Project	IEEE 802.16 Broadband Wireless Access Working Group < <u>http://ieee802.org/16</u> > Correction of inconsistencies in 802.16-2004 OFDMA mode repetitions and data mapping to burst	
Title		
Date Submitted	2004-09-02	
Source(s)	Yigal Leiba Yossi Segal Zion Hadad Itzik Kitroser Runcom Ltd.	Voice:+972-3-9528440 Fax:+972-3-9528805 yigall@runcom.co.il yossis@runcom.co.il zionh@runcom.co.il Itzikk@runcom.co.il
	Tal Kaitz Alvarion Ltd.	Voice: +972-36457834 Fax: +972-36456290 tal.kaitz@alvarion.com
	Yuval Lomnitz Yigal Eliaspur Intel	Voice: +972-547-884877 yuvall@envara.com yigal.eliaspur@intel.com
Re:	802.16REVd/D5-2004	
Abstract	Errata to 802.16-2004	
Purpose	Correction of inconsistencies in 802.16-2004	
Notice	This document has been prepared to assist IEEE 802.16. It is offered as a basis for discussion and is not binding on the contributing individual(s) or organization(s). The material in this document is subject to change in form and content after further study. The contributor(s) reserve(s) the right to add, amend or withdraw material contained herein.

Correction of inconsistencies in 802.16-2004 OFDMA mode repetitions and data mapping to burst

[Replace figure 217 on page 501 with the figure shown below]

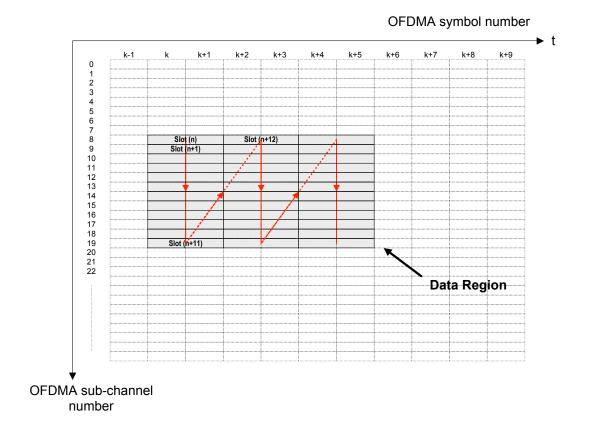
2) Each slot shall span one or more subchannels in the subchannel axis and three OFDMA symbol in the time axis (see Figure 217). Map the slots such that the lowest numbered slot occupies the lowest numbered subchannel in the lowest numbered OFDMA symbol.
3) Continue the mapping such that the OFDMA symbol index is increased (skipping allocations made with UIUC=12,13, see 8.4.54). When the edge of the UL zone (which is marked with Zone_switch_IE) is reached, continue the mapping from the lowest numbered OFDMA symbol in the next available subchannel

4) An UL allocation is created by selecting an integer number of contiguous slots, according to the ordering of steps 1-3. This results in the general Burst structure shown by the gray area in figure 217.

B. Step 2 – Map OFDMA slots within the UL allocation.

1) Map the slots such that the lowest numbered slot occupies the lowest numbered subchannel in the lowest numbered OFDMA symbol.

2) Continue the mapping such that the Subchannel index is increased. When the last subchannel is reached, continue the mapping from the lowest numbered subchannel in the next OFDMA symbol that belongs to the UL allocation. The resulting order is shown by the arrows in figure 217.
